Franklin Municipal Planning Commission

Thursday, June 28, 2018

**BERRY FARMS - REAMS FLEMING
SUBDIVISION
COF # 6722**

COF PROJECT # (6714)	
THE HIGHLANDS AT LADD PARK PUD SUBDIVISION, FINAL PLAT SECTION 36	
FRANKLIN, WILLIAMSON COUNTY, TENNESSEE	
TOTAL ACRES: 32.819	TOTAL LOTS: 20
ACRES NEW STREETS: 1.018	FEET NEW STREETS: 755±
CIVIL DISTRICT: 10TH	CLOSURE ERROR: 1:10,000+
SHEET 1 OF 4	DATE: 05-14-18

SHEET 3 OF 5

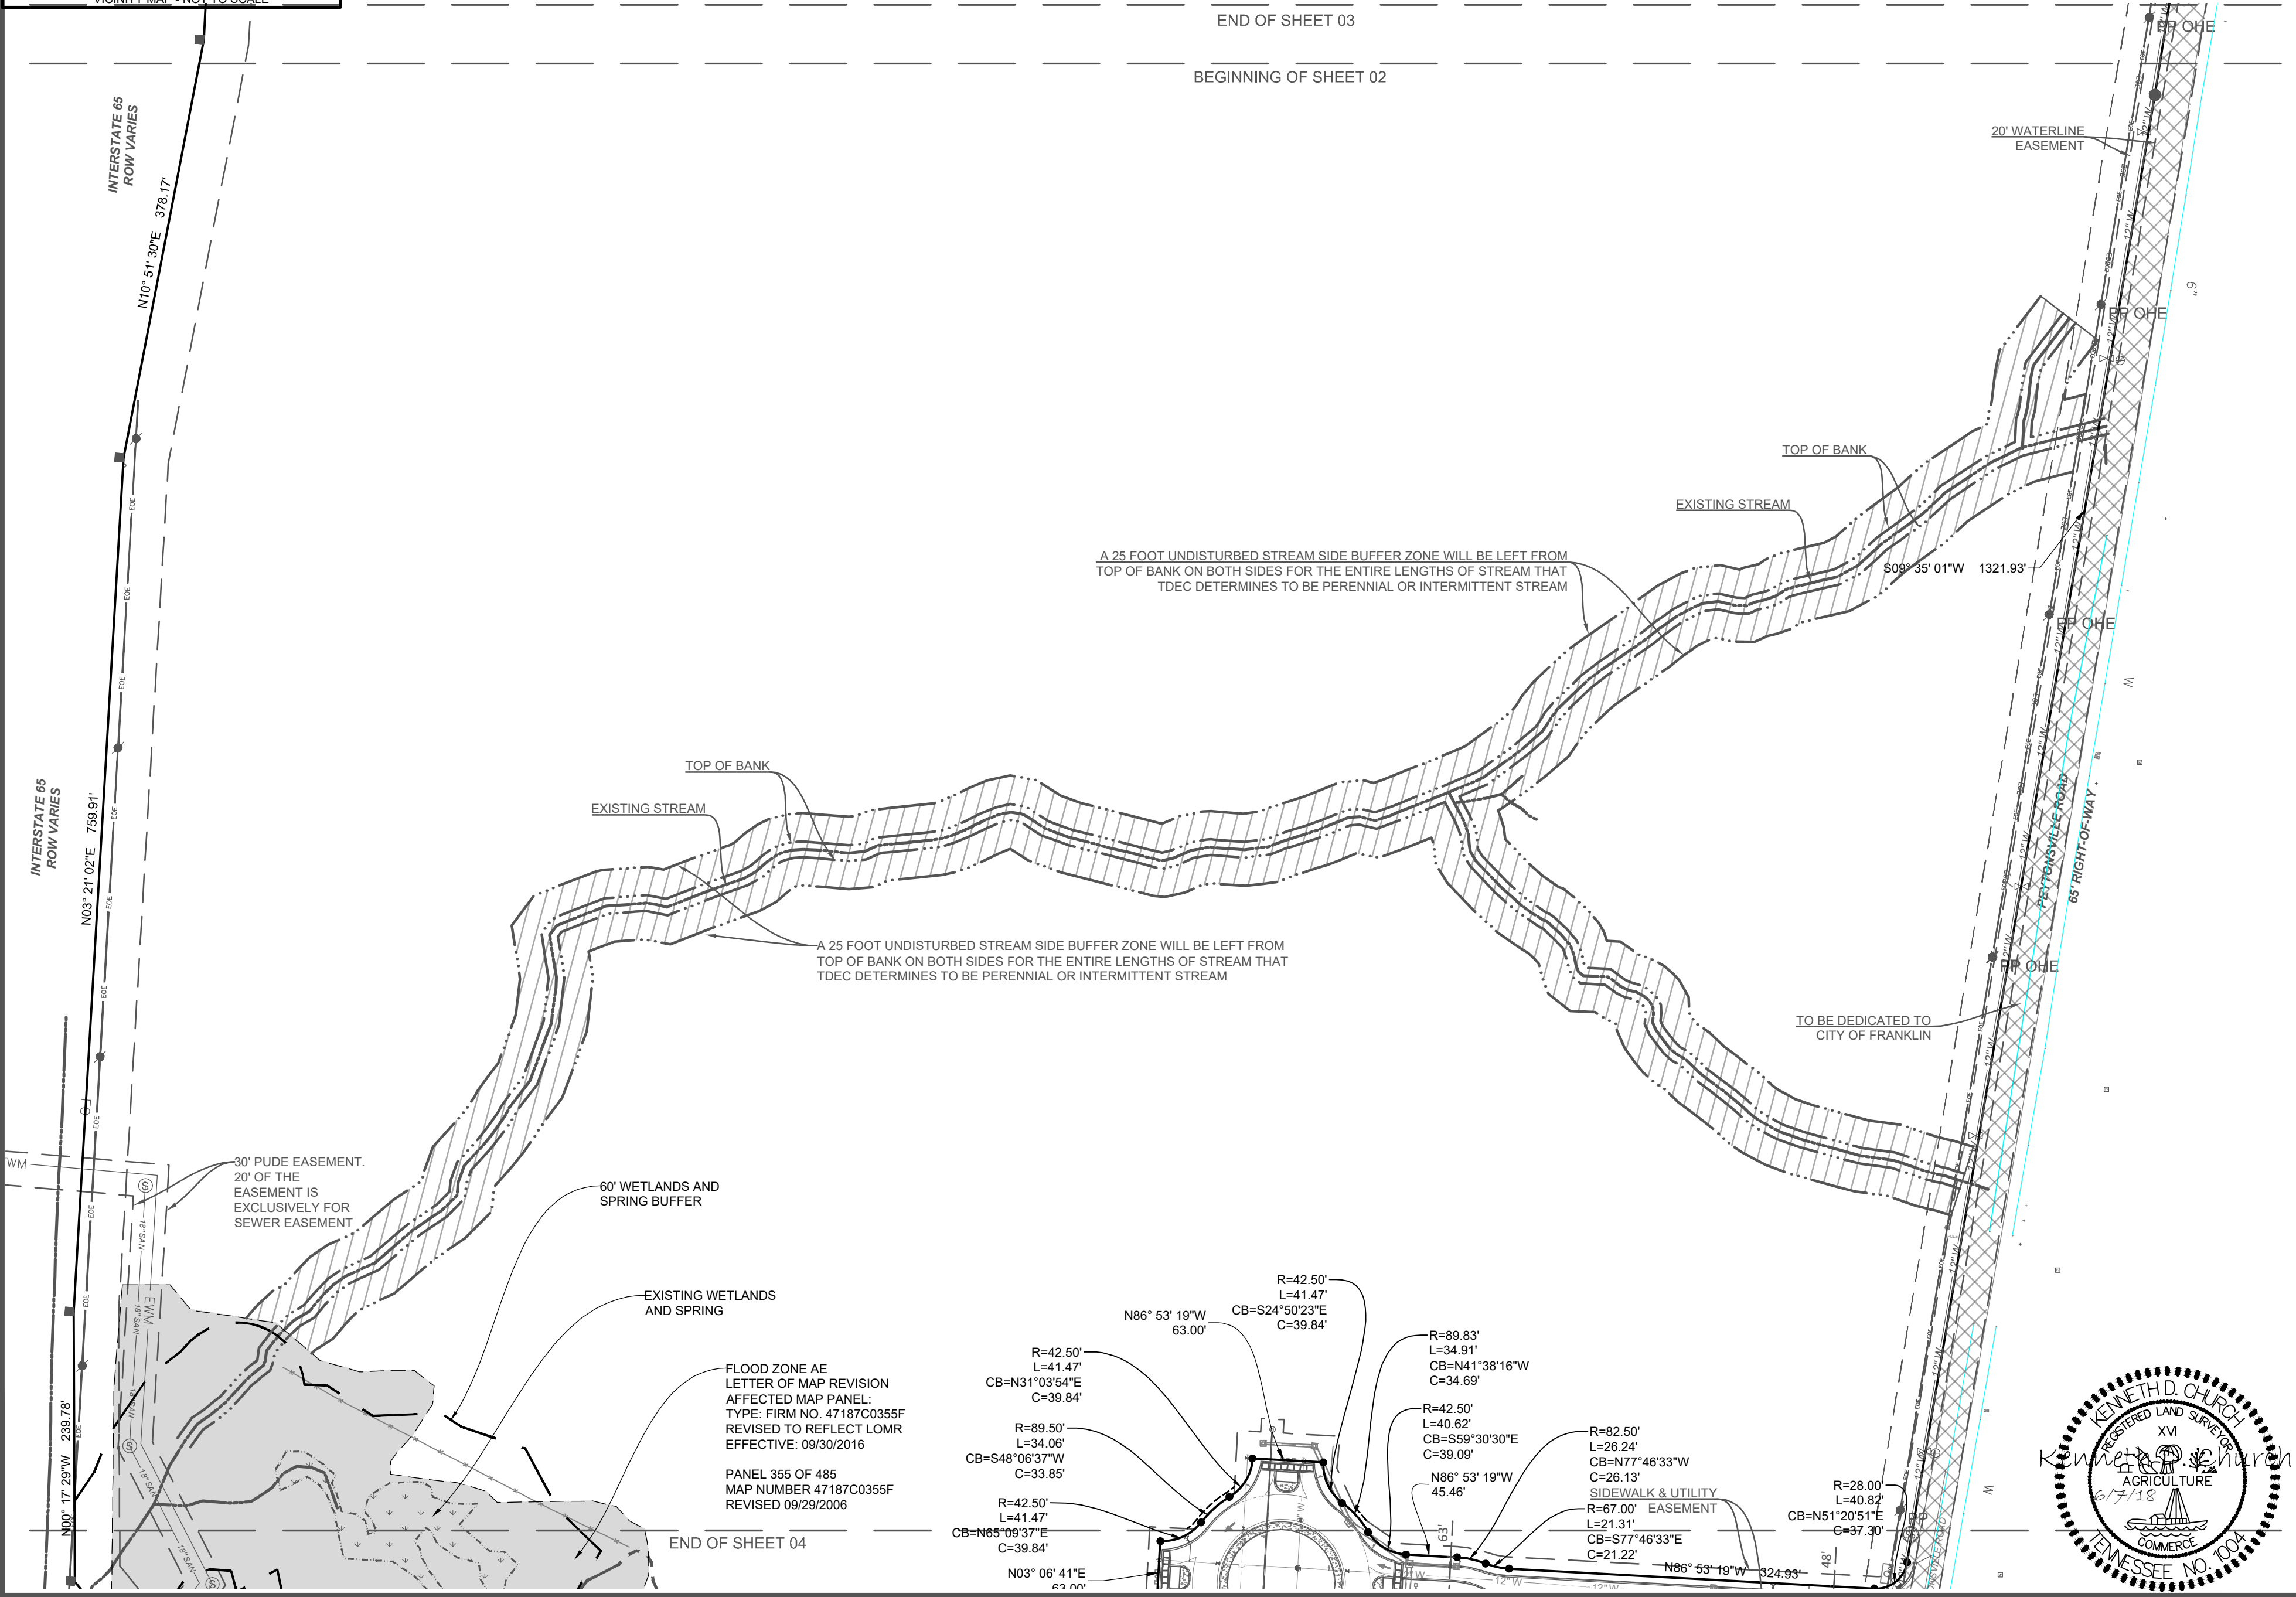
1. Label top of bank for Five Mile Creek, similar that for the conveyance shown on Sheet 3.
2. Revise the linetype for each top of bank of Five Mile Creek to be a single line with a consistent linetype matching that for the conveyance shown on Sheet 3. Currently, the top of bank linetype changes from single to double lines, each with a different linetype from that on Sheet 3, as shown in the following.

4. Verify the intended regulatory body (i.e. TDEC or USACE) for the stream buffer note on Sheet 3, as TDEC does not use "perennial or intermittent" stream terminology.

Sheet No.
SHEET 2 OF 5

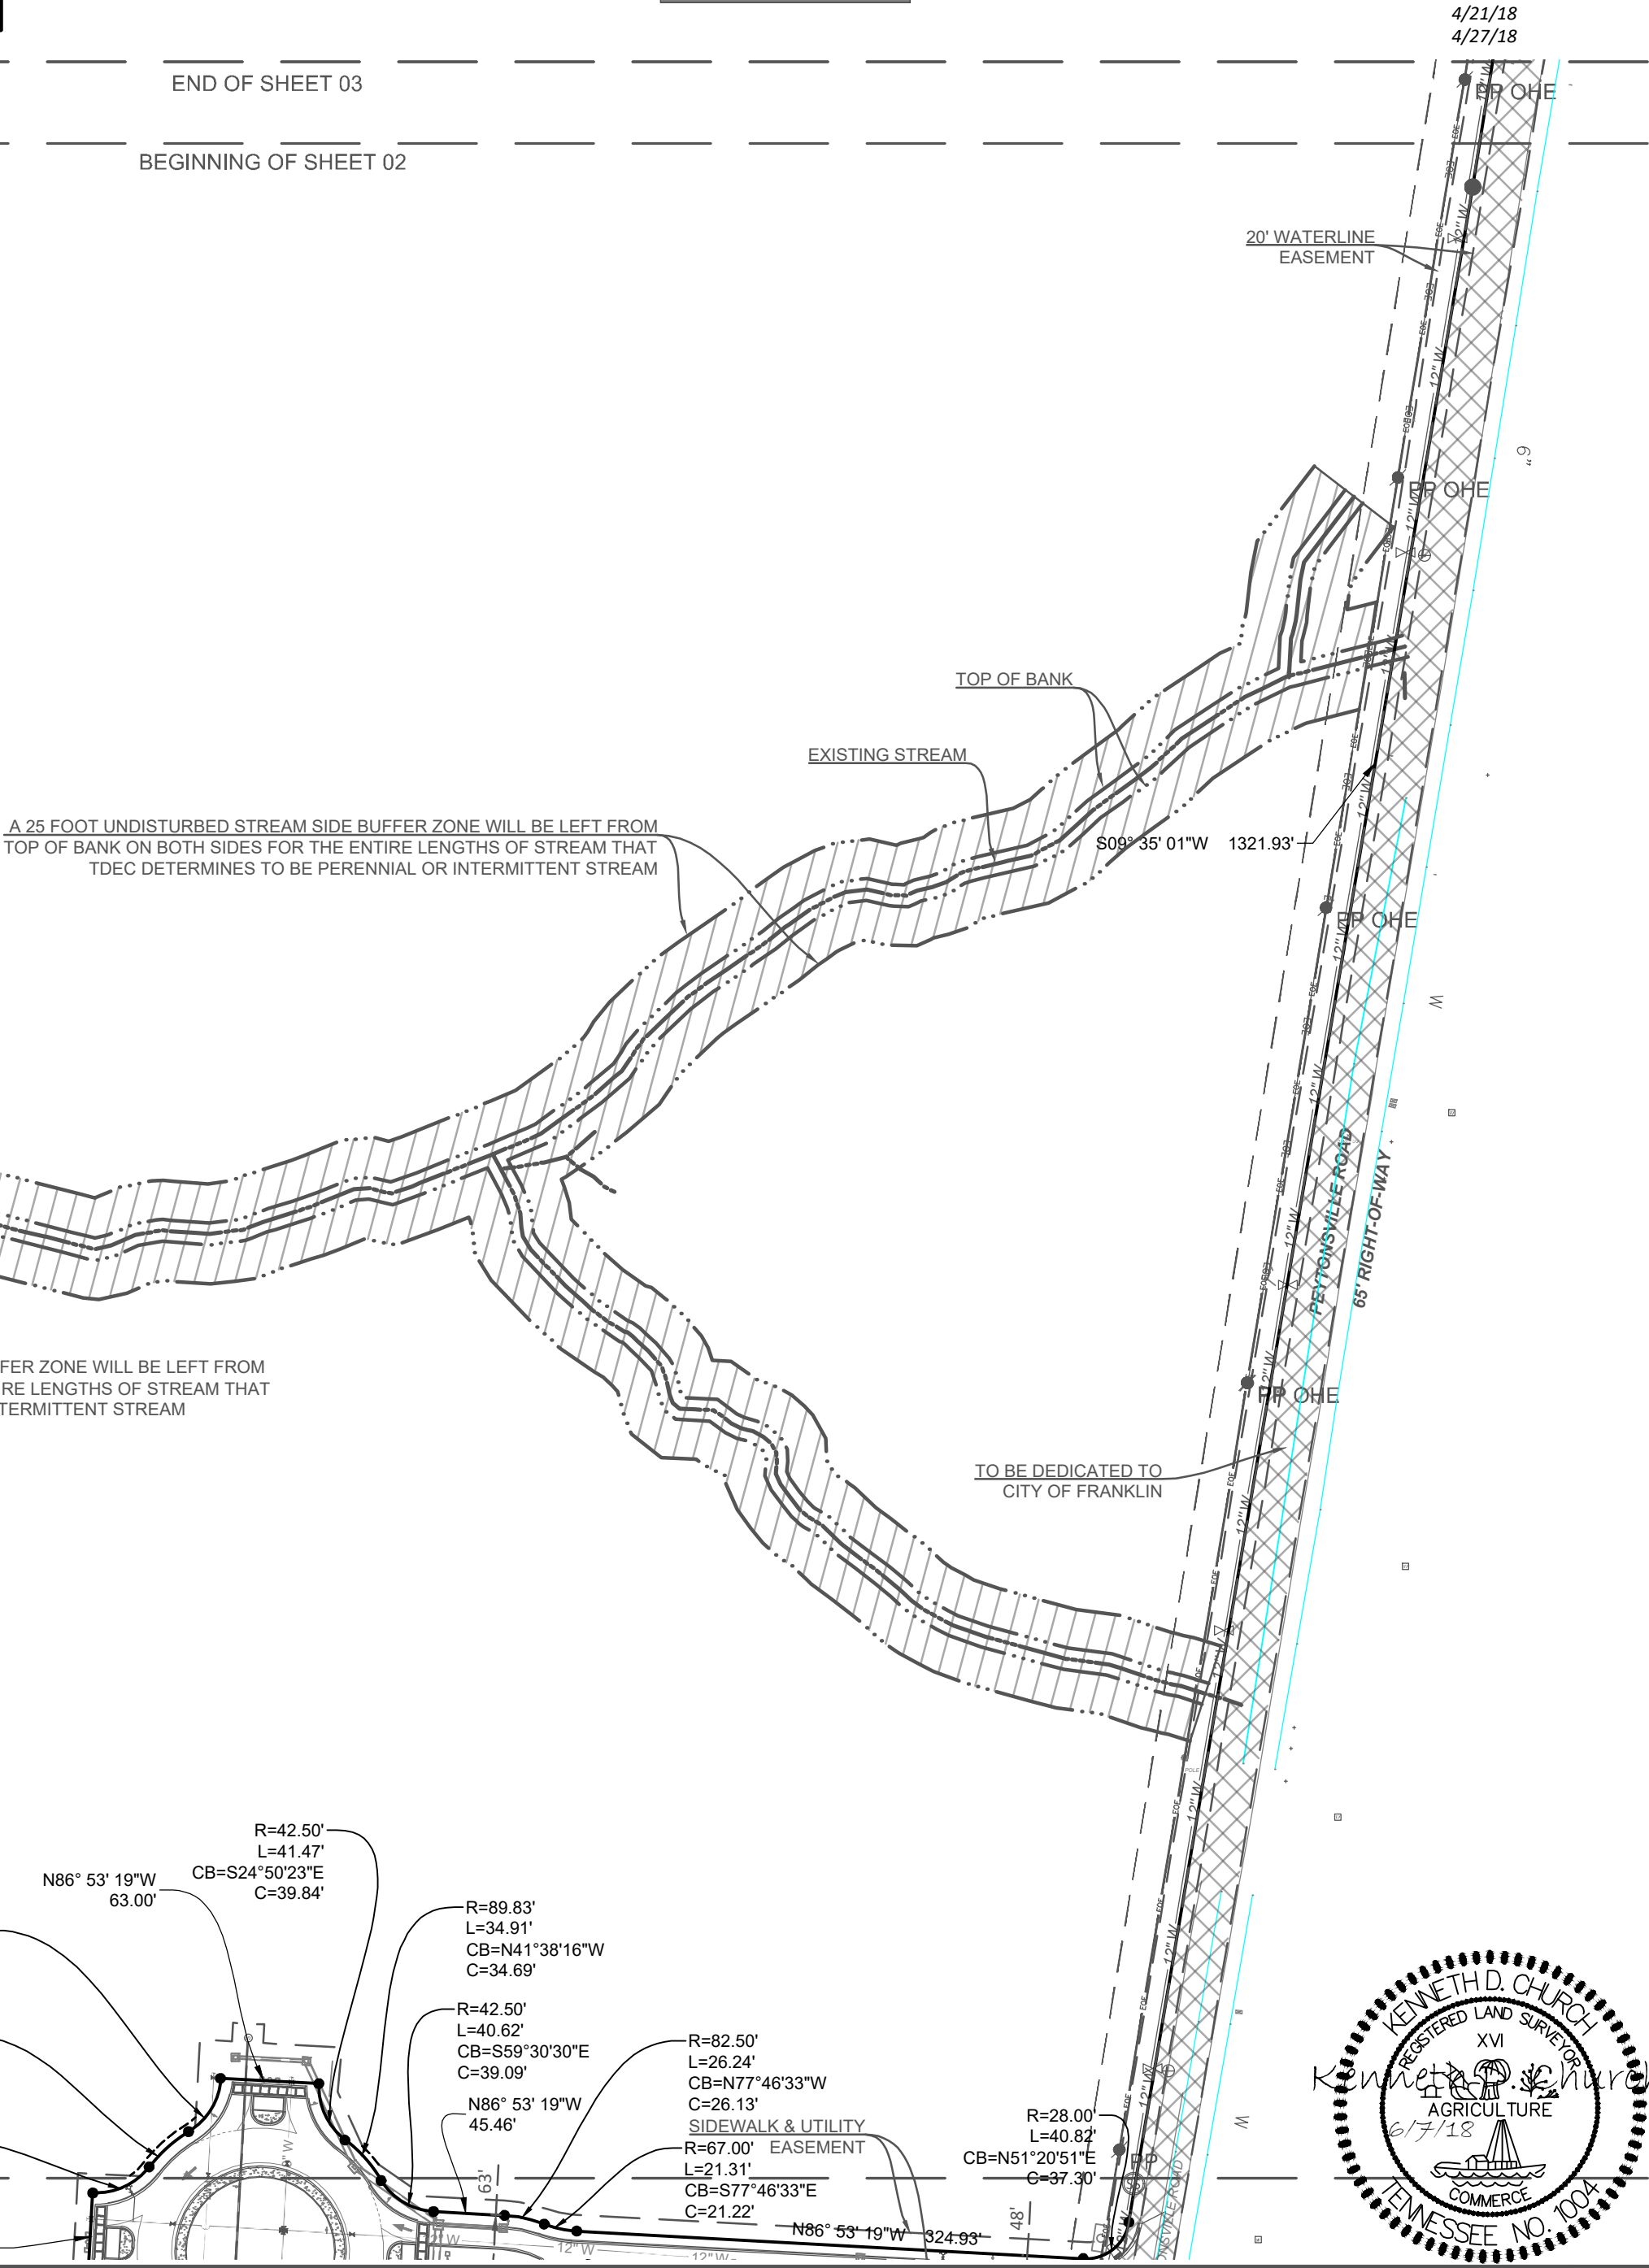
2. Sheets 2-5: Sheets show an assumed utility easement along Peytonsville/Pratt, but it is not labeled, dimensioned, and appears to show only one side of the easement.

2. Sheets 2-4: Correct waterline information in Pratt/Peytonsville that does not appear to be associated with a line.

COF PROJECT # (6714)	
THE HIGHLANDS AT LADD PARK PUD SUBDIVISION, FINAL PLAT SECTION 36	
FRANKLIN, WILLIAMSON COUNTY, TENNESSEE	
TOTAL ACRES: 32.819	TOTAL LOTS: 20
ACRES NEW STREETS: 1.018	FEET NEW STREETS: 755±
CIVIL DISTRICT: 10TH	CLOSURE ERROR: 1:10,000+
SHEET 4 OF 4	DATE: 05-14-18

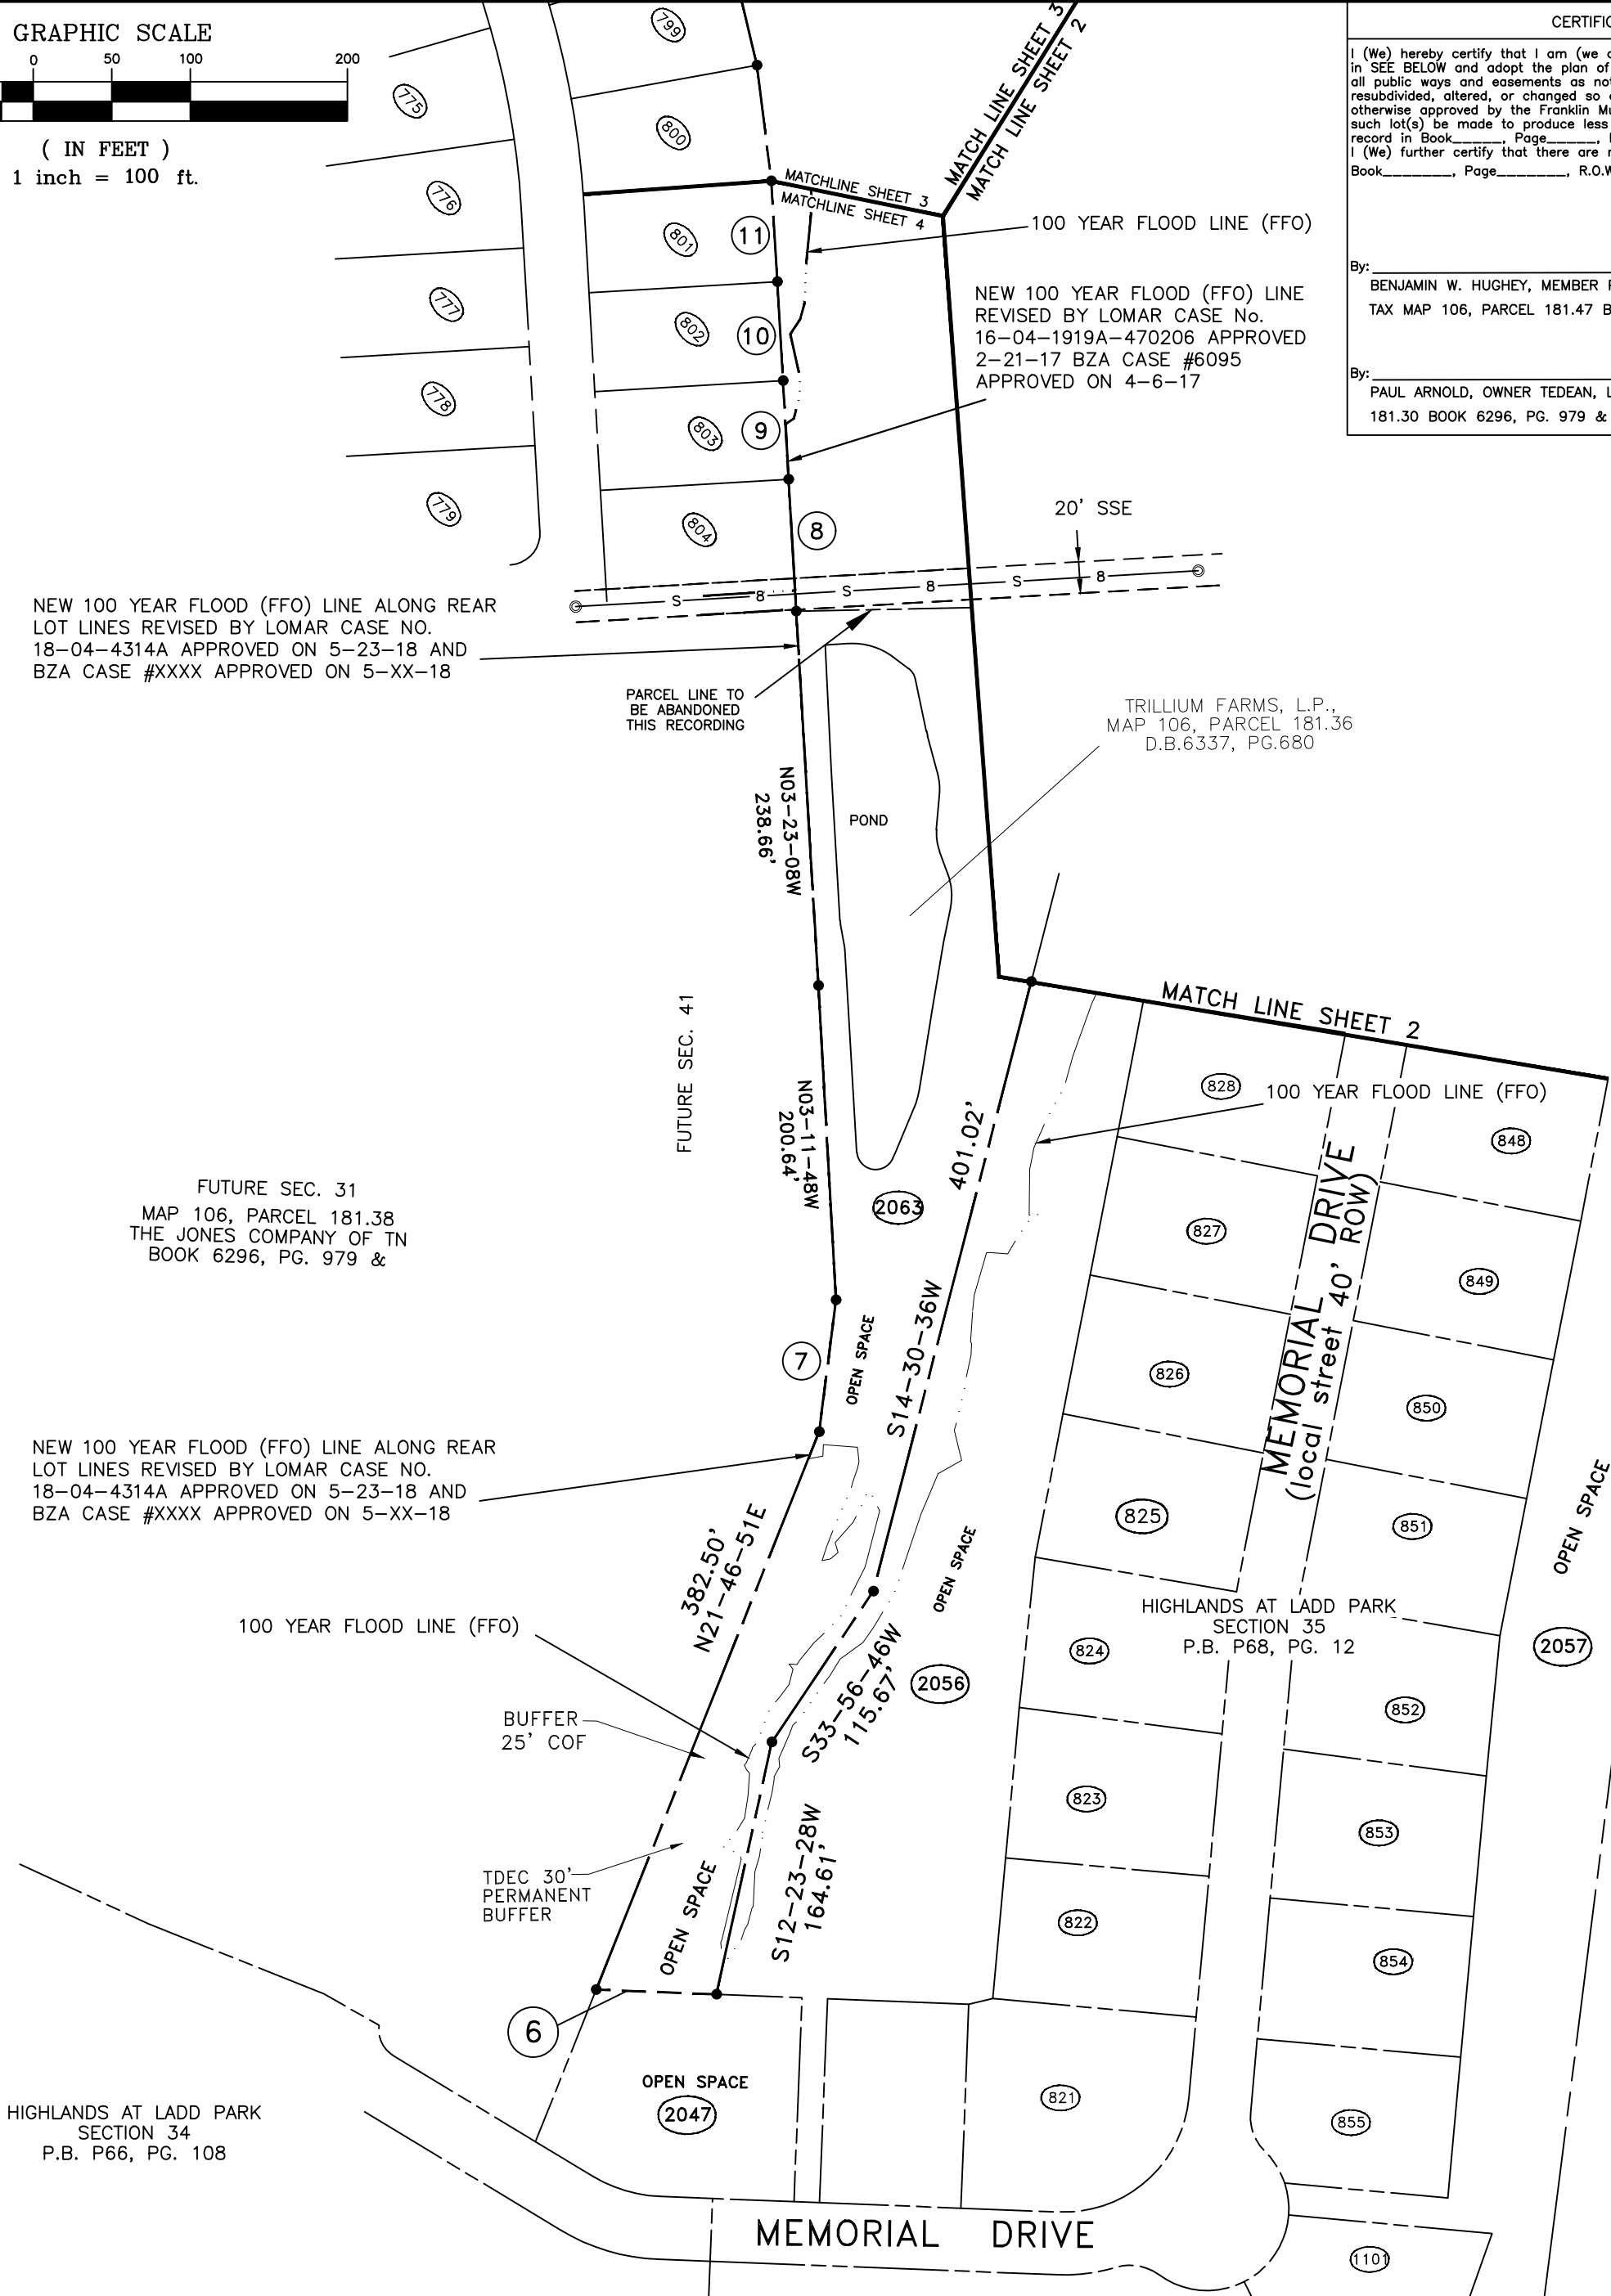
The match line highlighted below on Sheet 4 is not in the same location as other corresponding match lines in the final plat set. Applicant to revise match lines such that they are consistently shown in the same location.
